MODIFICATION RECOMMENDED

N9916A-01

S E R V I C E N O T E

N9916A - FieldFox Handheld Analyzer

Figure 1: No sidebands issue

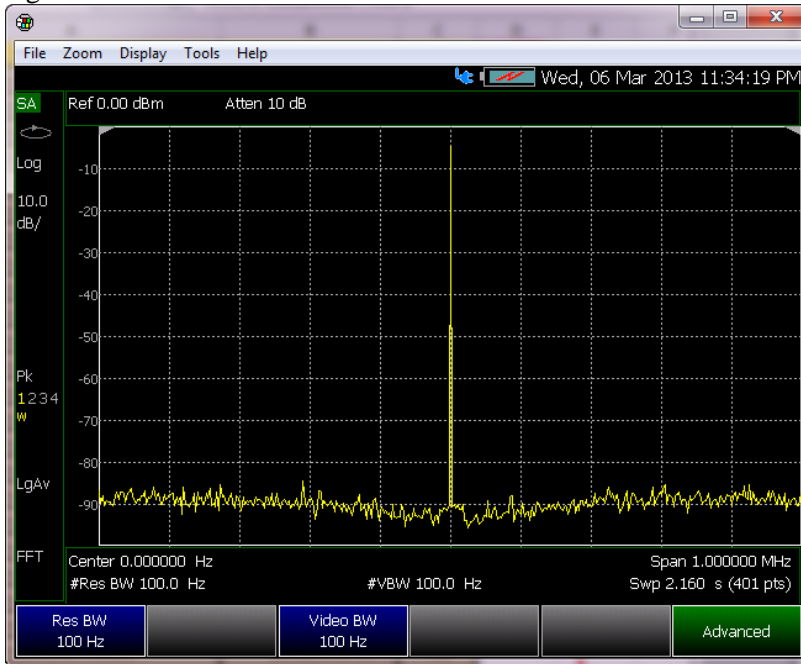
RF board earlier than Rev 7 may have sidebands issue due to oscillation by the voltage regulator. After it is fixed by replacing a new inductor, the RF board revision header will be updated to reflect the change.

Figure 1 shows a good RF signal, and Figure 2 shows FieldFox with sidebands issue.

Affected FieldFox are required to send back to Agilent factory for RF board reliability enhancement. The RF board revision header will be updated to reflect the change. Test and Adjustment shall be done before shipping back to customer.
